DEVELOPMENT REVIEW COMMITTEE (DRC) COMMENT REPORT

PROJECT NAME: 1700 N Andrews

CASE NUMBER: UDP-S23010

REQUEST: Site Plan Level II Review: 4,889 Square-Feet of
Commercial Use and 11 Townhouse residential units

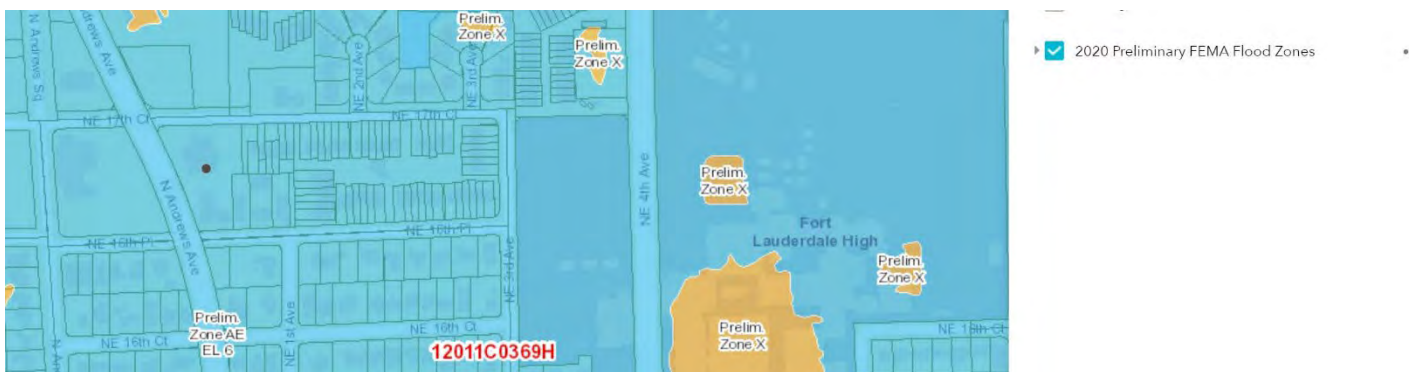
- 1. Provide the following flood zone data on the site plan (for the existing FEMA flood zone 2014 FIRM), (see attachment of 2014 FIRM).
